MILITARY SPECIFICATION

TERMINI, FIBER OPTIC CONNECTOR, REMOVABLE,
GENERAL SPECIFICATION FOR

This amendment forms a part of MIL-T-29504A, dated 19 December 1989, and is approved for use by all Departments and Agencies of the Department of Defense.

MIL-T-29504A
AMENDMENT 2

3.8: Delete and substitute:

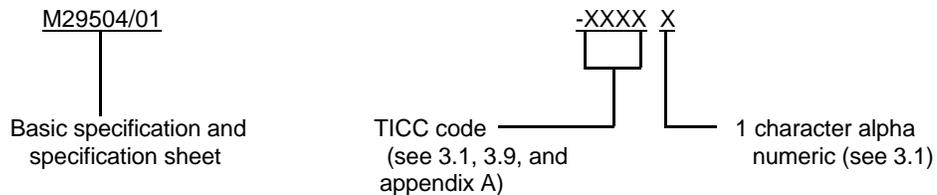
"3.8 PIN construction. Each terminus shall be identified by four distinct color bands indicating the TICC as specified herein (see 3.1, 3.9, and appendix A). The PIN shall be as specified in the military specification sheets (see 3.1), but shall be defined in the following format:
